TECHNICAL EVALUATION REPORT
DAVIS-BESSE NUCLEAR POWER STATION
STATION BLACKOUT EVALUATION

TAC No. 68536

Final
August 17, 1990

U.S. Nuclear Regulatory Commission
Washington, D.C. 20555

Figure 1

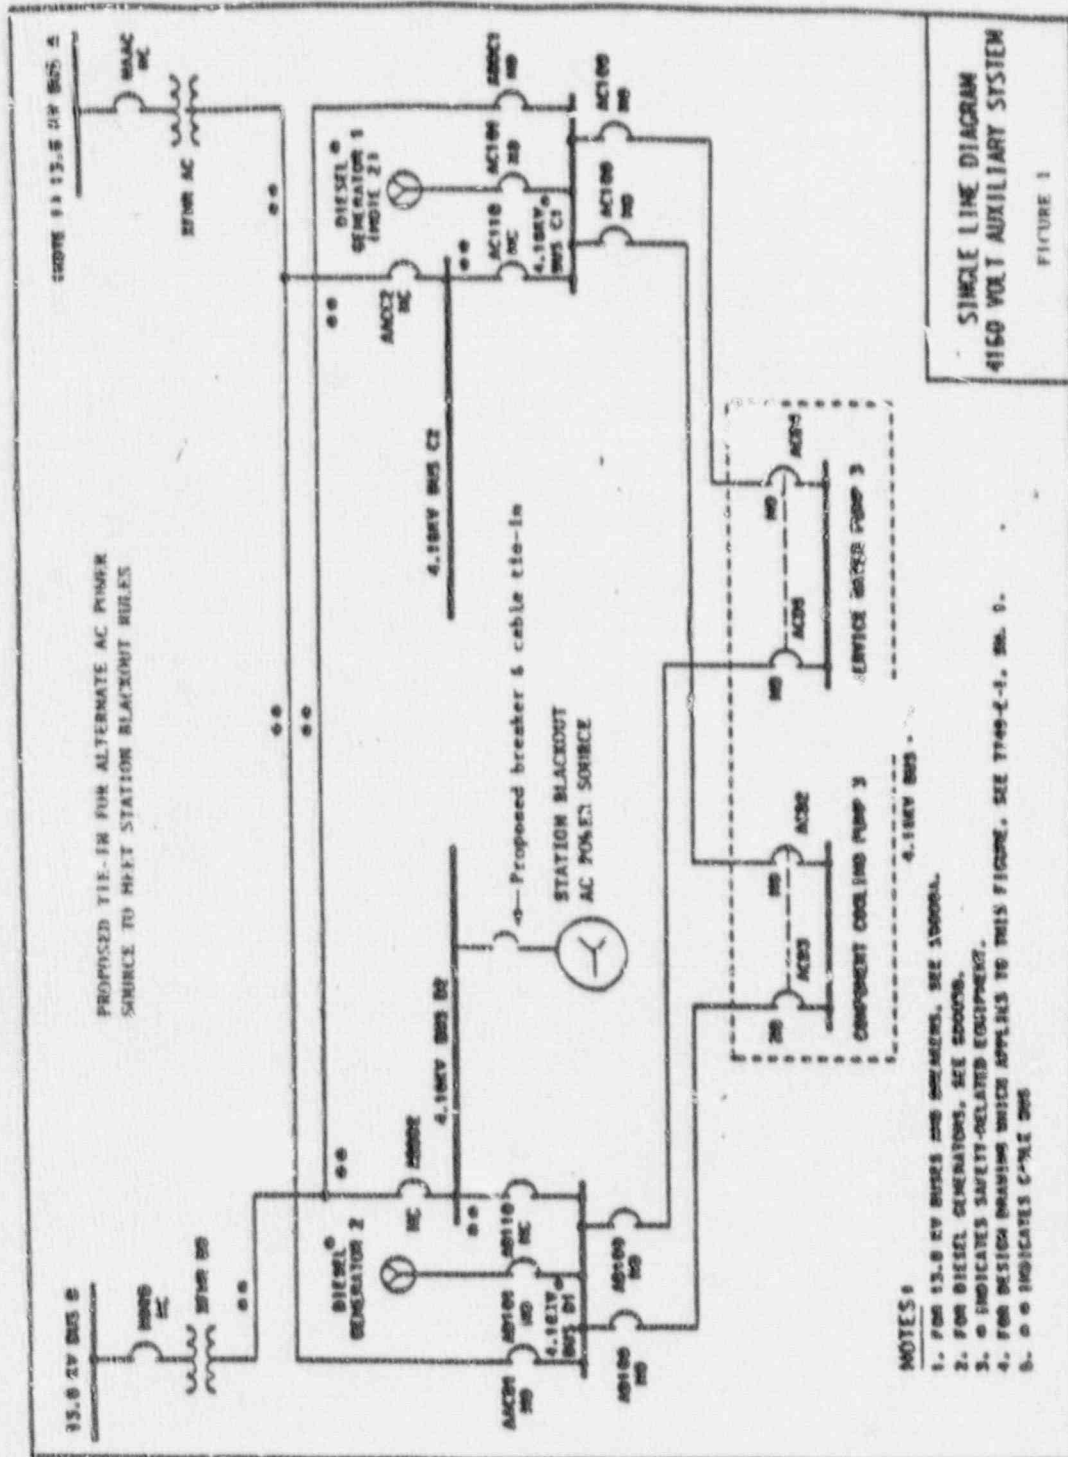
The licensee stated that the independence of the plant offsite power system (Figure 1) grouping is "1 1/2." A review of the DBNPS USAR indicates that:

The licensee proposes to install a diesel generator (DG) as an AAC power source, see Figure 1 (10). The licensee stated that, once the modifications are completed, the AAC power source will meet the criteria specified in Appendix B to NUMARC 87-00. The AAC power source will be available within ten minutes of the onset of an SBO event, and will have sufficient capacity and capability to operate systems necessary for coping with an SBO for a four hour duration.

Although the licensee is committed to install a non-class 1E diesel which meets the criteria specified in Appendix B of NUMARC 87-00, the licensee did not provide any technical information to evaluate the AAC power source. Since the AAC is available within 10 minutes and no AC-independent coping has been performed, it is assumed that the AAC source will power all the required functions during an SBO event. Our estimate of the SBO loads indicate that the proposed AAC power source should have approximately the same capacity as the present EDGs. If the proposed AAC power source is of less capacity than the present EDGs, then the licensee needs to provide analysis of the required loads for the SBO event. In addition, in the interest of safety it is preferred that the proposed AAC power source be capable of being connected to both essential division buses. The present configuration shows that the proposed AAC is only capable of being connected to one division.

The licensee's action is consistent with the guidance of NUMARC 87-00, Section 7.1.2. This is based on the assumption that the proposed AAC power source is available to CIVs requiring closure capability during an SBO event. The single line diagram, see Figure 1, indicates that the proposed AAC power source will be available to power one division of essential buses. The licensee needs to determine if appropriate containment integrity can be assured with the AAC power source available only to one division.

The licensee did not provide technical information on the proposed modifications to review. We believe the proposed modifications enhance the plant ability to cope with an SBO event. We have one concern, however. Although neither NUMARC 87-00 nor RG 1.155 specifies that the AAC power source be connectible to both divisions of essential buses, we believe this connectibility provides a flexibility that would not be available otherwise. It is true that we should not consider any other equipment failures during an SBO event. However, should one of the required equipment on one division be out for maintenance the redundant equipment can be made operational on the other division only if such connectibility exists. The present configuration shows that the proposed AAC is only capable of being connected to one division.
